Red Text = The El Passo County Comments Rev. 0

Green Text = The Engineer of Record answers on the El Passo County Comments Rev. 0 for Variance of Use project

PROJECT NAME: VARIANCE OF LAND USE

PROJECT ADDRESS: 1185 N Curtis Rd, Colorado Springs, CO

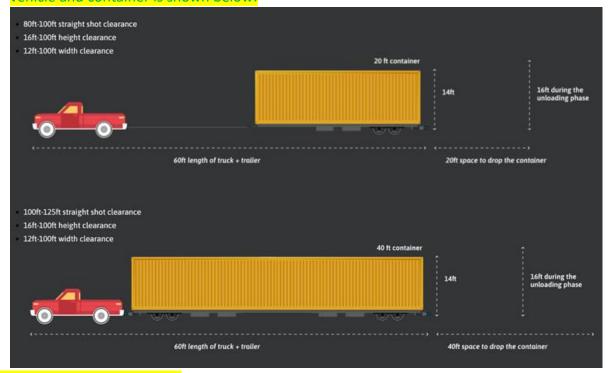
- 1. buildings associated with the use
 - ✓ No buildings associated with use.
 - ✓ Existing One Level House will be abended.
- 2. where will equipment be stored?
 - ✓ One equipment, snow plow, will be sorted on parking lot close to the Existing One Level House as presented on Sheet #: S-2.
- 3. parking? if any, provide dimensions and number of spots
 - ✓ Container Storage Spots (CSS) will be located on each property line with the middle open for truck maneuvering. Each space is 45 ft long and 12 ft wide and has total 120 feet straight line clearance for pickup truck with container trailer as presented on Sheet #: S-2. The visual presentation of the container transport vehicle and container is shown below:

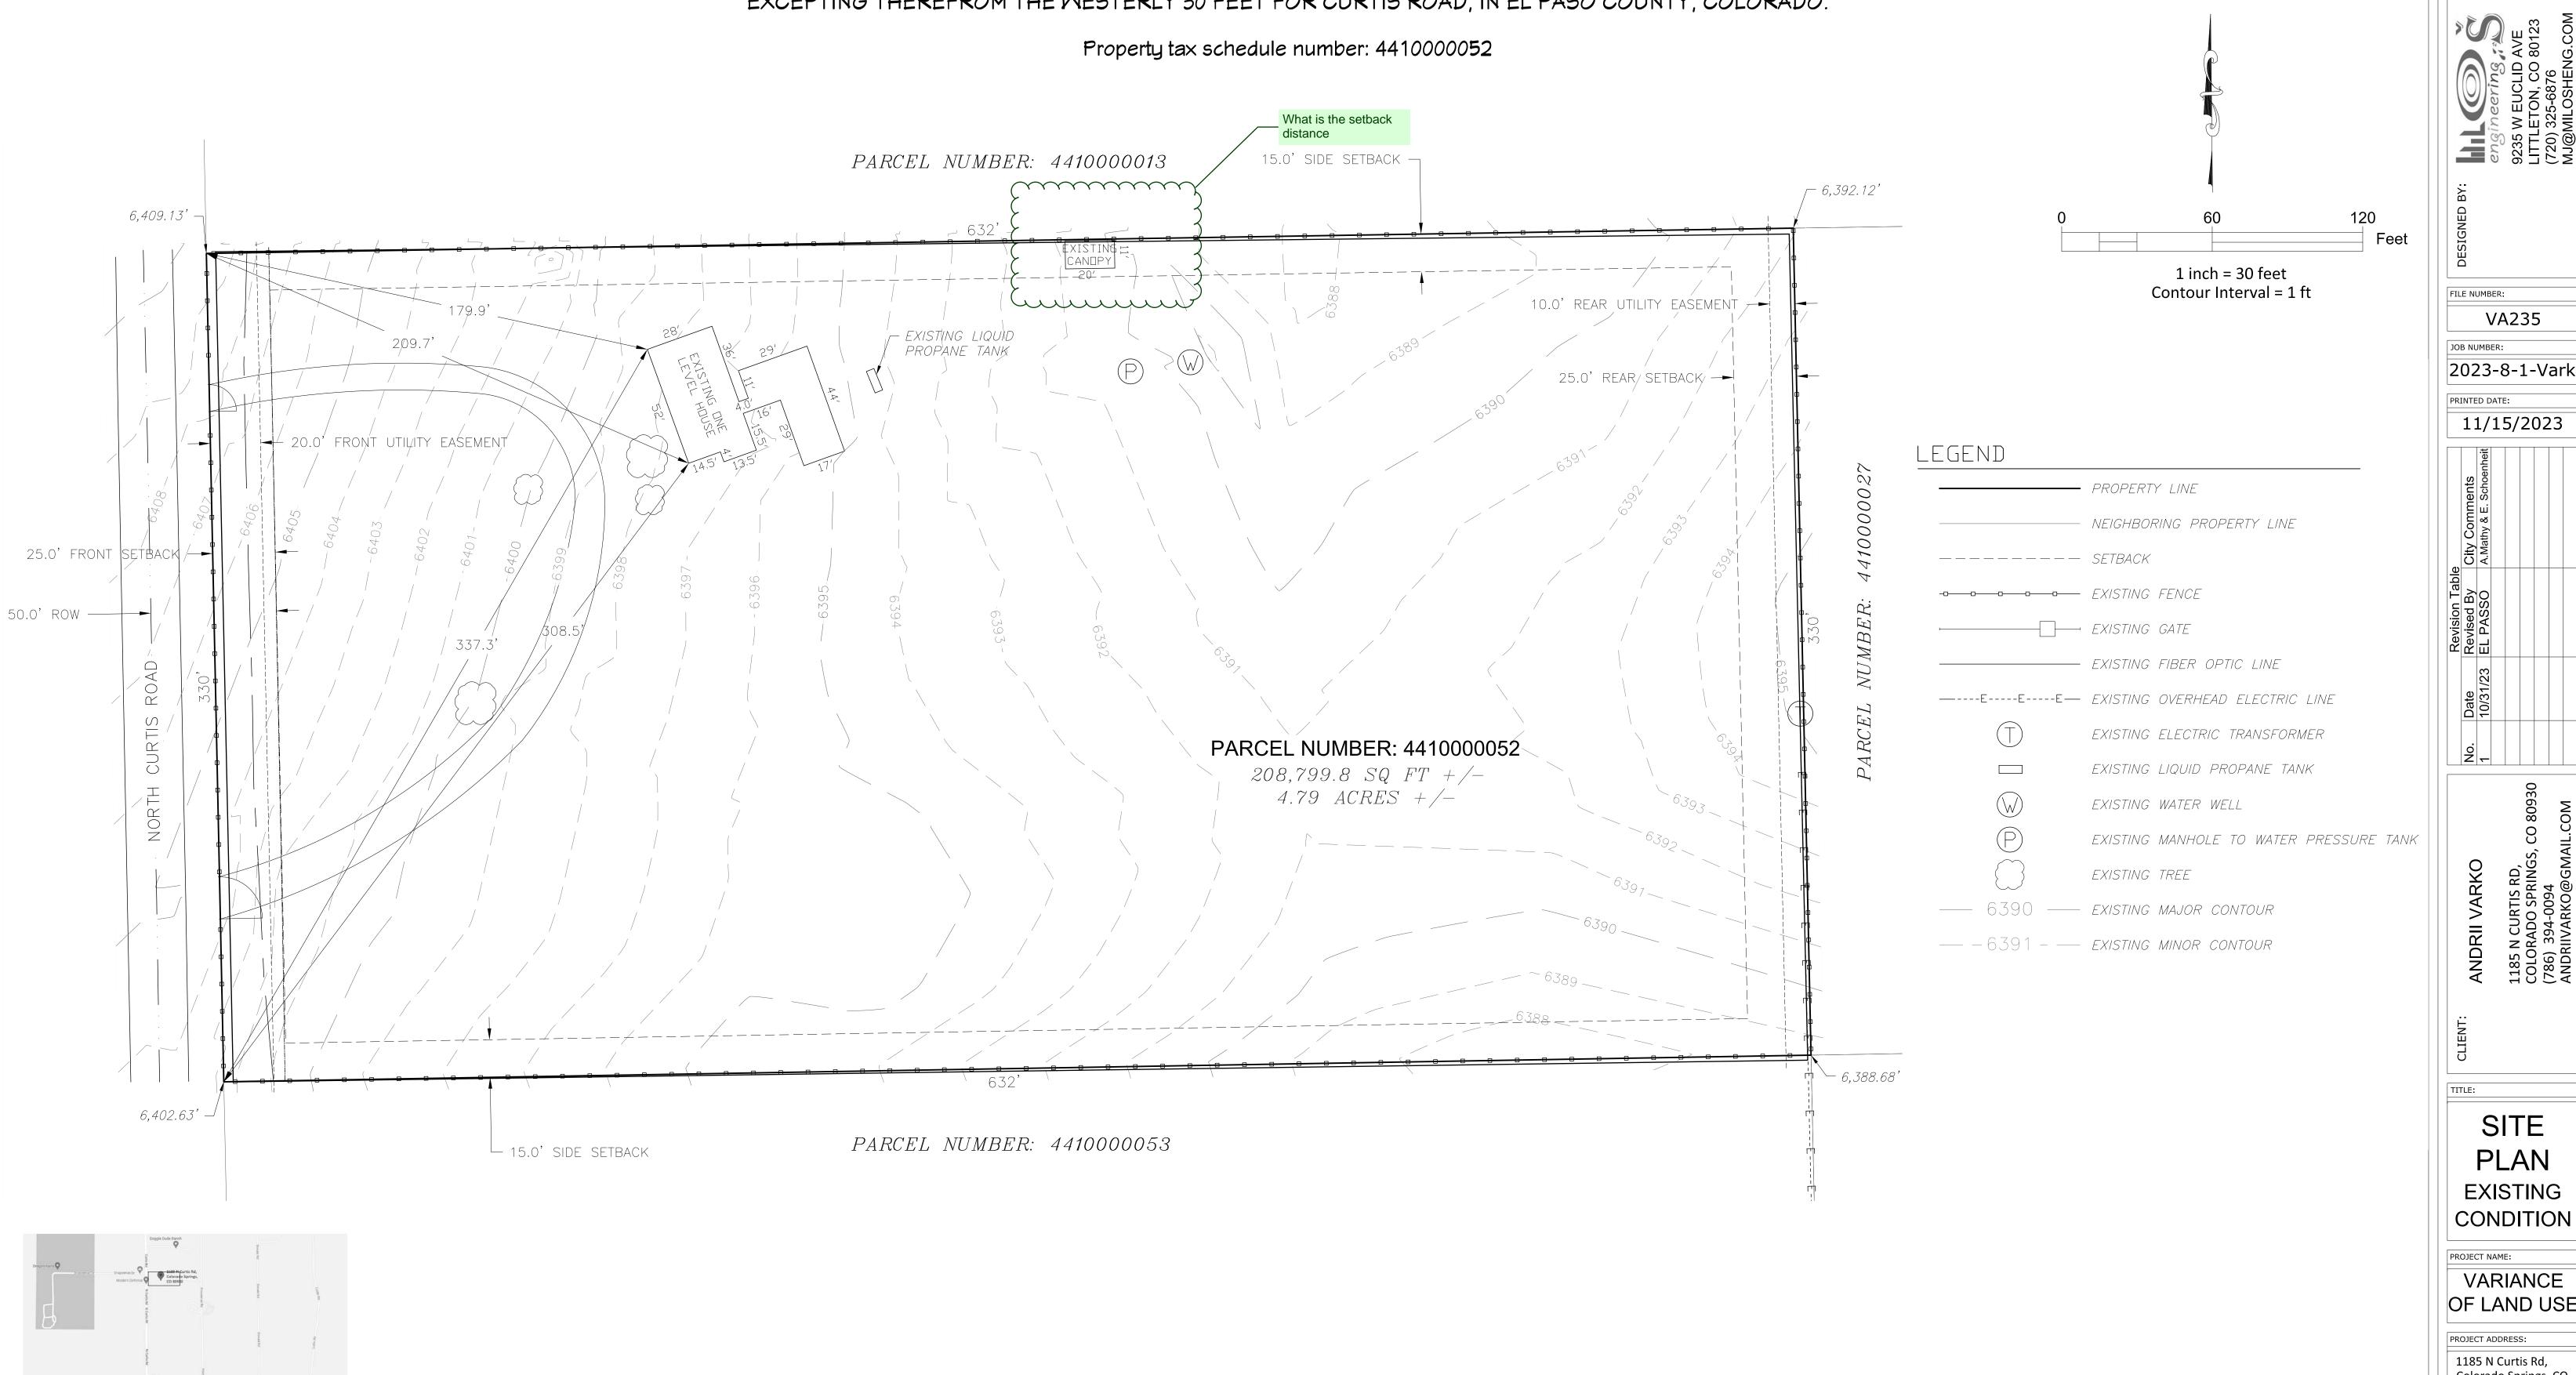
- ✓ Plan for required water quality and detention structures with required landscaping is presented on Sheet #: S-2.
- 31. Add the scale in text
 - ✓ The scale in text is presented on Sheet #: S-1 and S-2.
- 32. Please update fencing to reflect requirements of code:
 - (2) Materials Screened by Solid Fence or Vegetation. Outside storage shall be enclosed and concealed by a solid fence or wall at least 6 feet in height or any combination of berming, shrubs, trees fencing or walls which will provide at maturity a minimum of 6 feet of height and 100% opaque screening for the area utilized for outside storage.
 - ✓ Fencing is update to reflect requirements of code as presented on Sheet #: S-3.

- (3) Outside Storage Not to Exceed Height of Screening. Outside storage or stacked materials shall not exceed the height of the screening fence except for operable vehicles, trailers, or other equipment designed to be towed or lifted as single component.
 - ✓ This code is satisfied since all equipment are designed to be towed or lifted as single component.

SITE PLAN **EXISTING** CONDITION

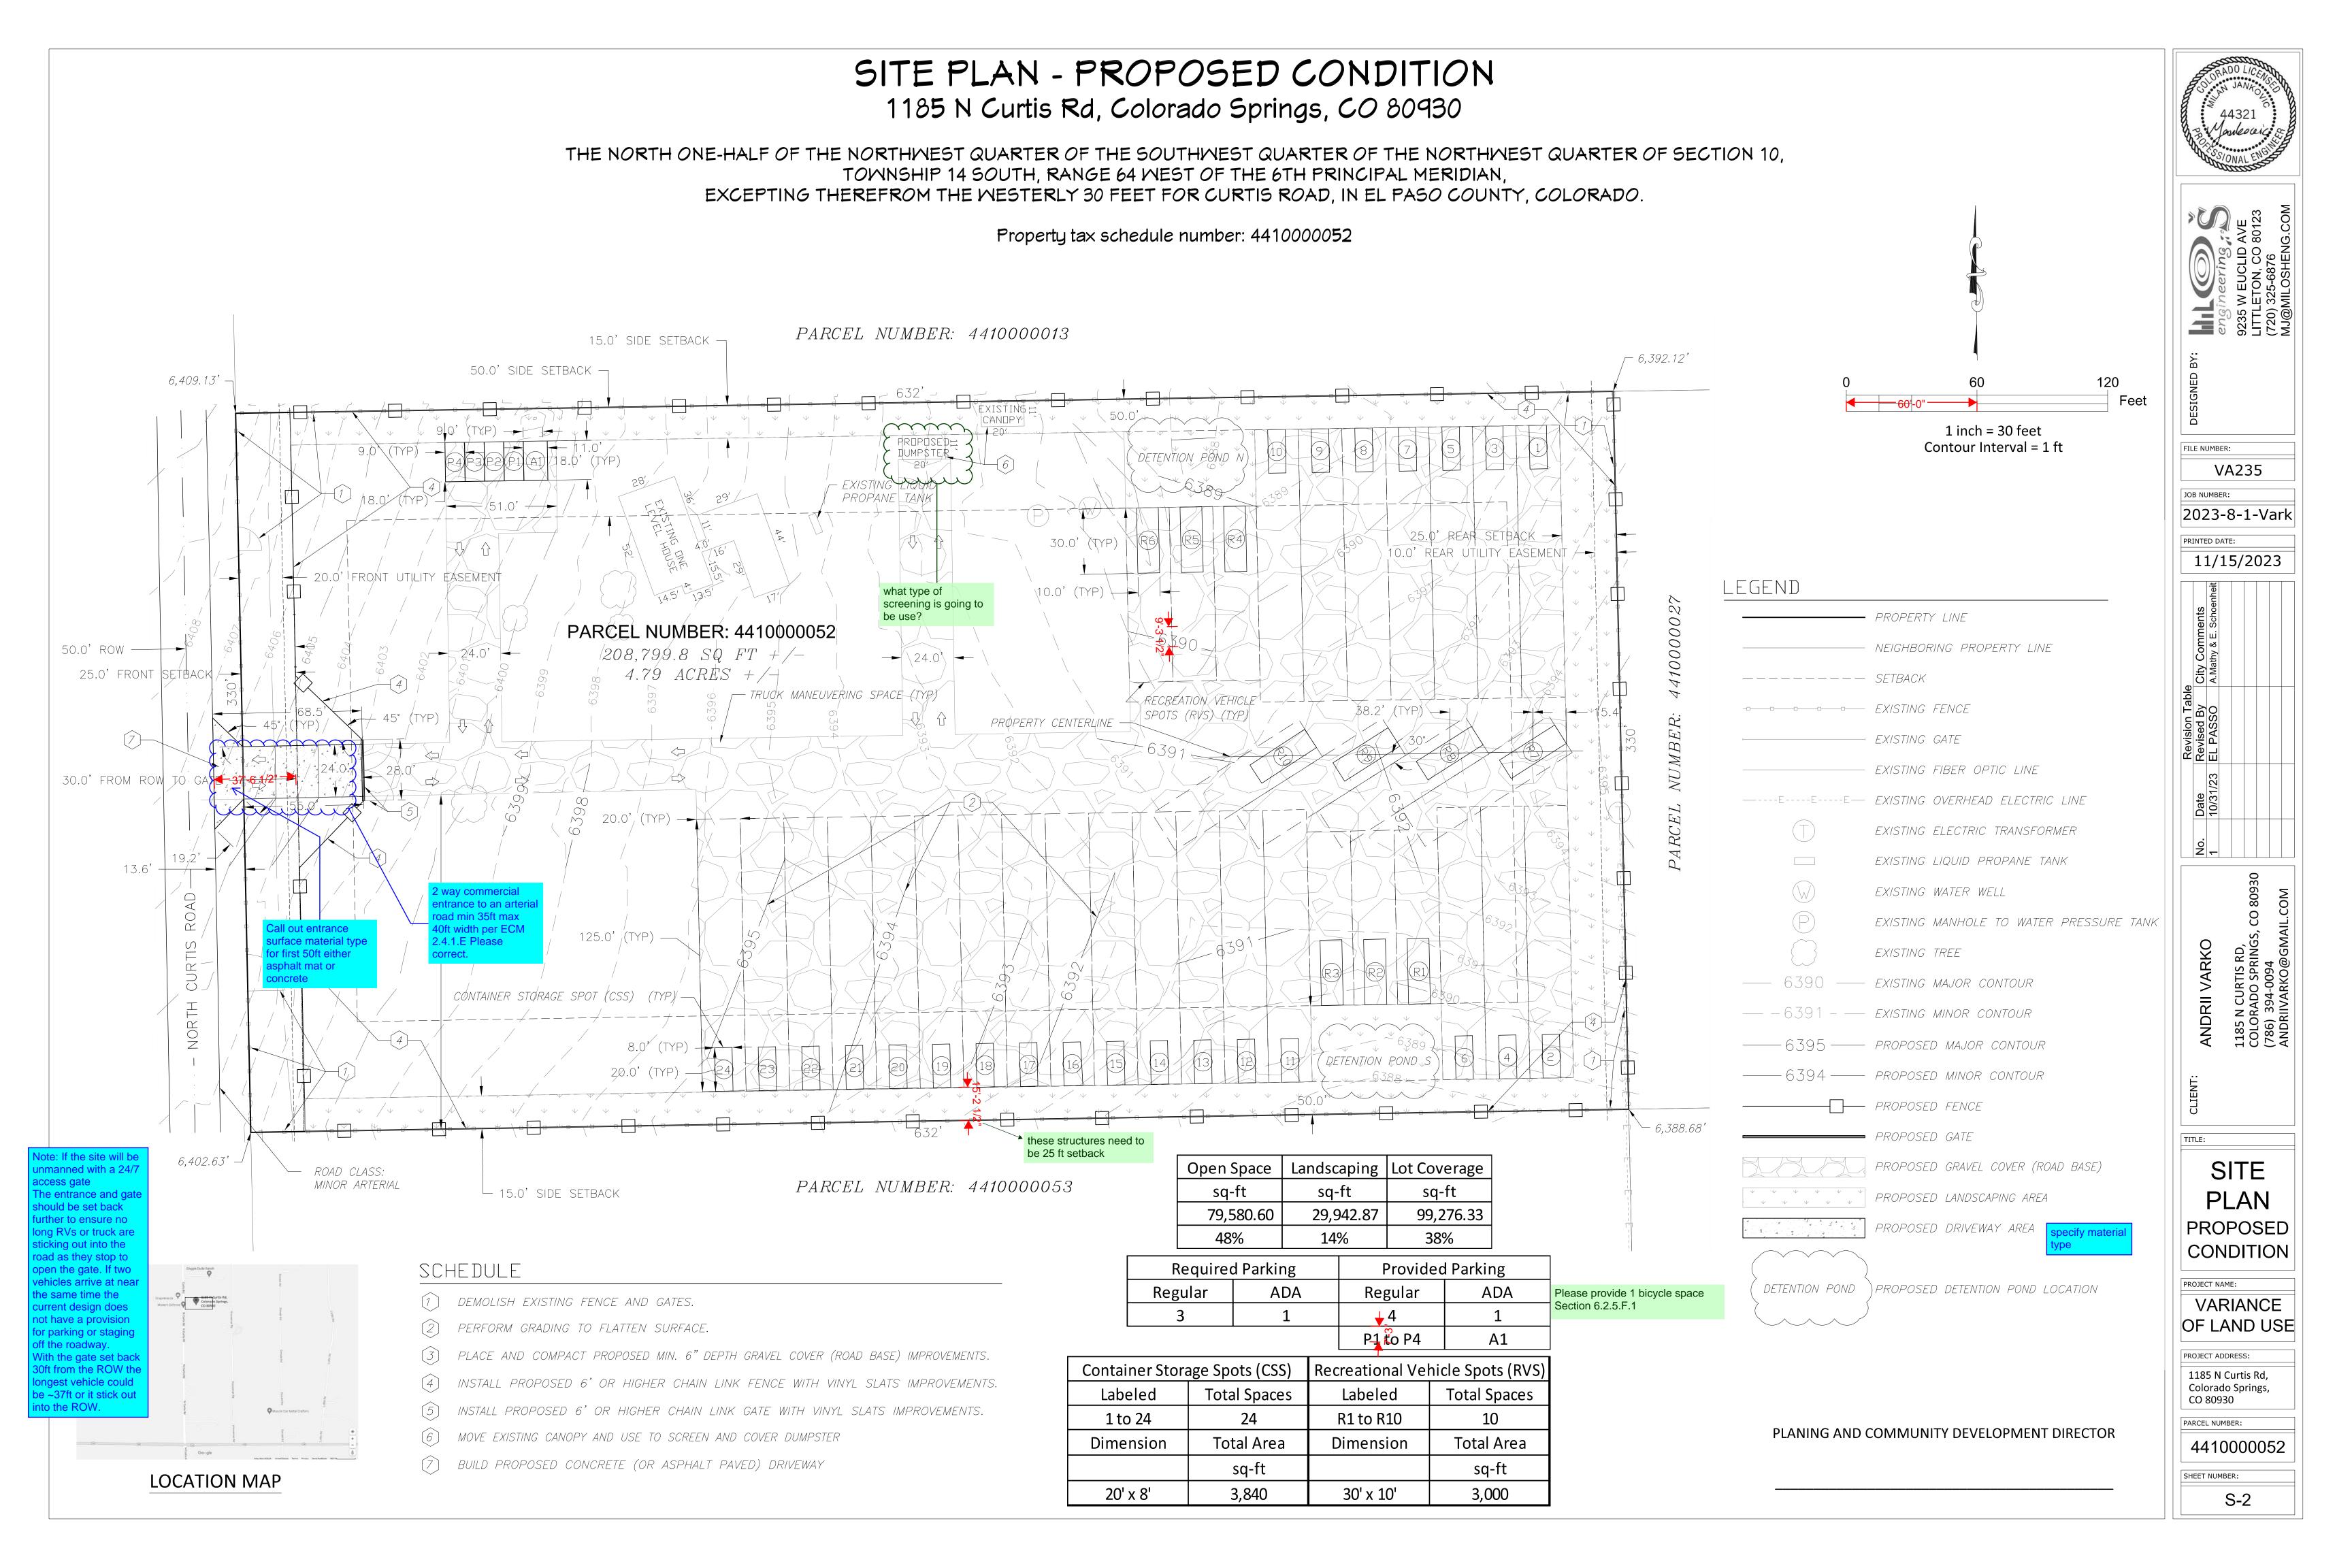
- 4. dimensions of all buildings on site
 - ✓ Dimensions of all buildings on site are presented on Sheet #: S-1 and S-2.
- 5. ROW and easement location

- ✓ ROW is 50 ft from North Curtis Road centerline and utility easement is 20 ft on front and 10 ft on rear of the site as presented on Sheet #: S-1 and S-2

1) TYPICAL FENCING DETAIL

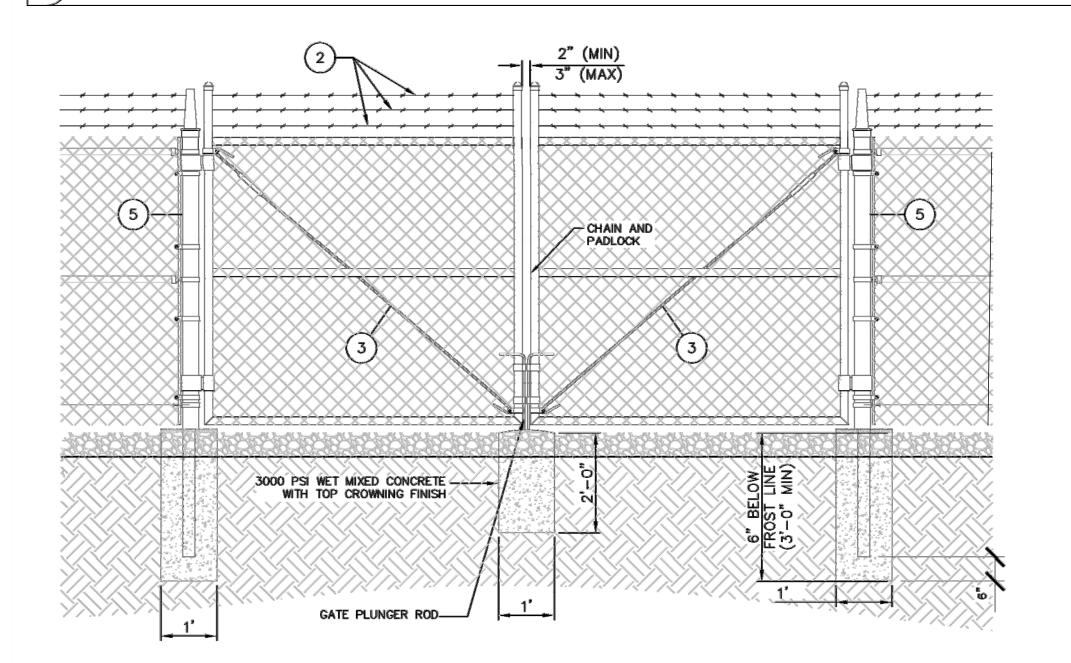
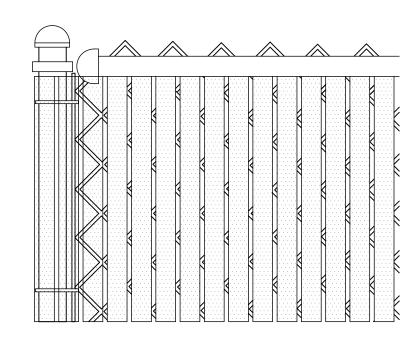
Anything over 7 ft will require a separate building
